**TITLE:** PUBLIC HEARING regarding a vacation of Tract 1, Thunder Basin Estates, 5<sup>th</sup> Filing, and Tract 19, Thunder Basin Estates, 2<sup>nd</sup> Filing, and approval of a Small Subdivision Permit and Plat for Roots to Branches End, Laramie County, WY.

PZ-26-00031

ROOTS TO BRANCHES END  
SUBDIVISION PERMIT AND PLAT

**ROOTS TO BRANCHES END**

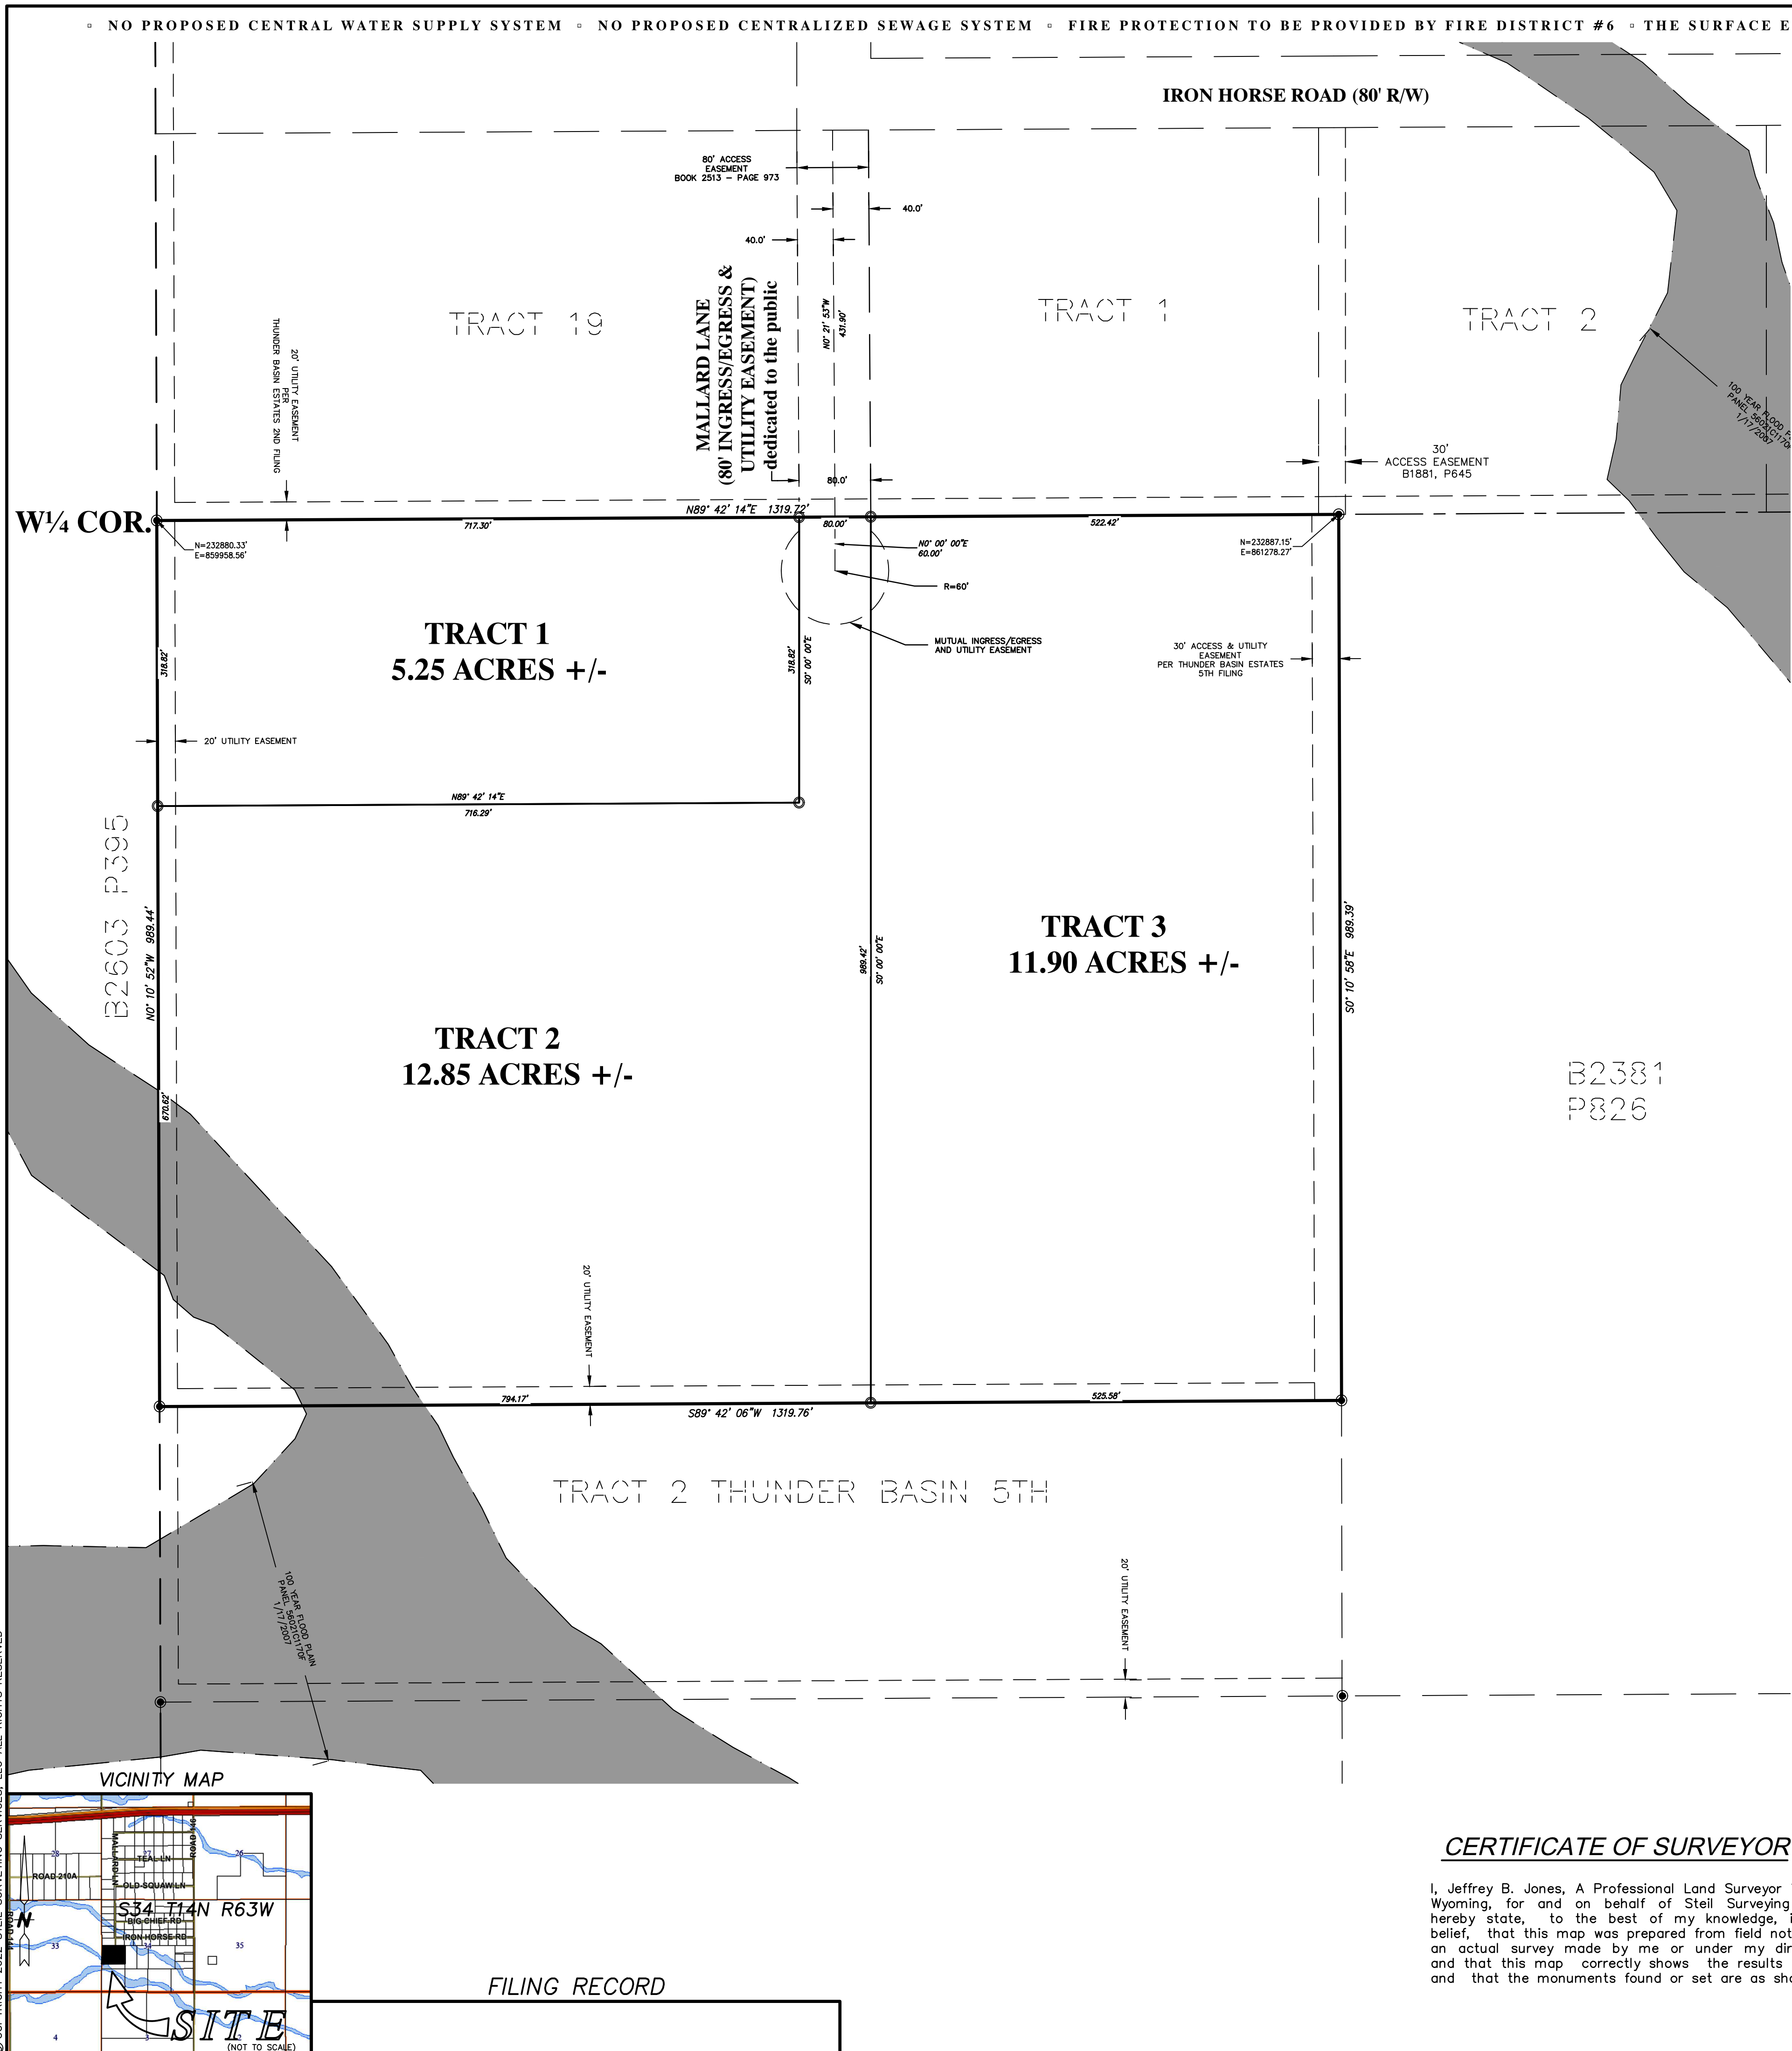
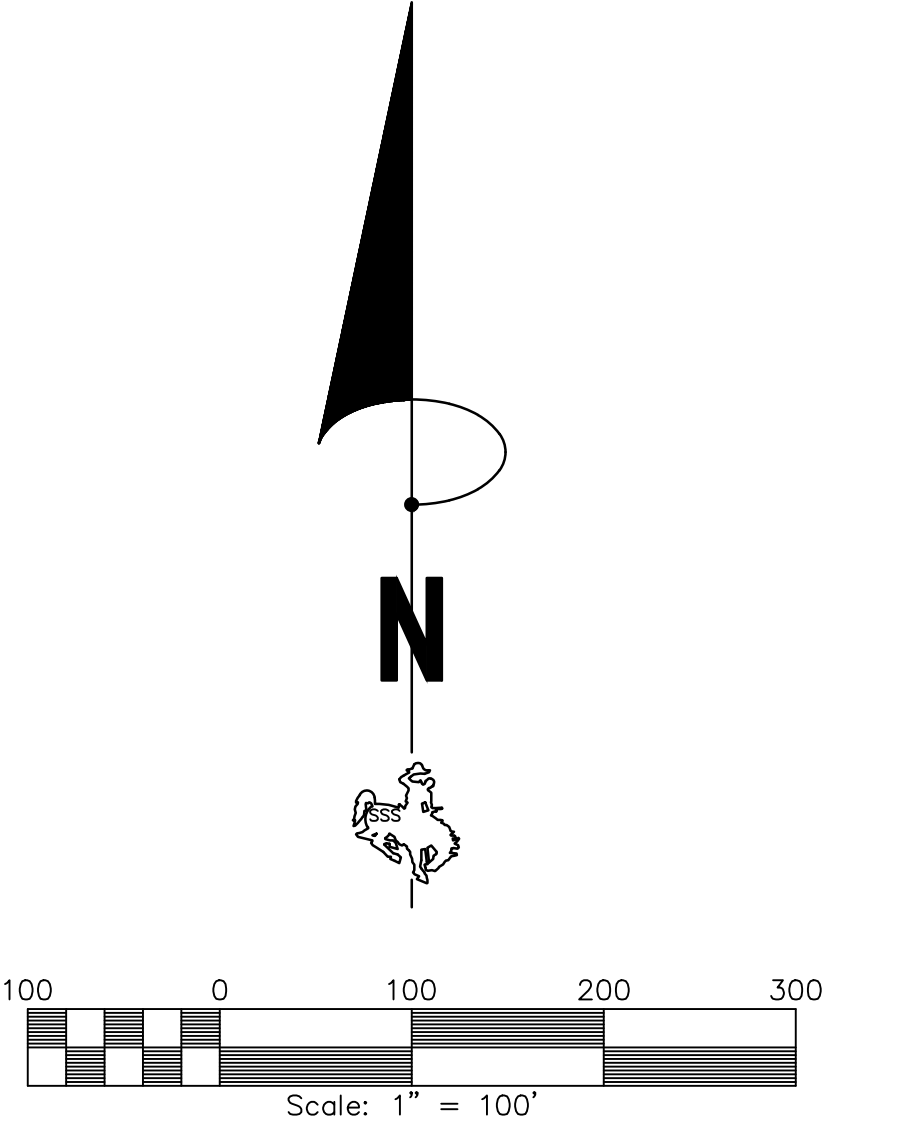
2. In the 3rd line of the Dedication states "Thunder Basin 5th Filing" and it should be "Thunder Basin Estates 5th Filing".

3. The Legend does not include all the various line types, shading/hatching, etc. used on the plat drawing.

4. The note "There shall be no public maintenance of internal roadways or access easements" should be added to the plat.

1. Just left of the Vacation Statement, there is a label "B2381 P826". Is this pertinent to the plat, and if so, it should be explained on the plat.

1. It appears access for these lots is intended to be from Mallard Lane.  
 1a. the road reservation will not suffice as dedicated right-of-way for this subdivision.  
 1b. If the applicant would like to pursue this location for access, the "roadway" shall be dedicated to the public and the adjacent property owners would need to sign off as well on the plat.

6. A note shall be added to the plat indicating "there will be no public maintenance of internal roadways/access easements."  
 7. A note shall be added to the plat indicating "All Tracts are to be accessed off internal roadways/access easements."

- 2. corrected
- 3.added
- 4. added

- 1. it is an easement label for the access to tie to the 30' easement access for the Tract south of this subdivision.

- 1. ack - await county access direction
- 2. It could if the parcel owner were to allow it.
- 3. ack
- 4. ack
- 5. ack
- 6. ack
- 7. ack
- 8. ack

<p>The land owner of THUNDER BASIN ESTATES, 2ND FILING: TRACT 19, BLOCK 1 is going to sign the plat to create the access.</p>					
04/27/2026	Workflow	PUBLIC WORKS REVIEW	GENERAL	<p>1. Access shall be defined based on comments from review engineer. No approval by myself until then.</p>	MOLLY.BENNETT @LARAMIECOUNTY WY.GOV
<p>The land owner of THUNDER BASIN ESTATES, 2ND FILING: TRACT 19, BLOCK 1 is going to sign the plat to create the access.</p>
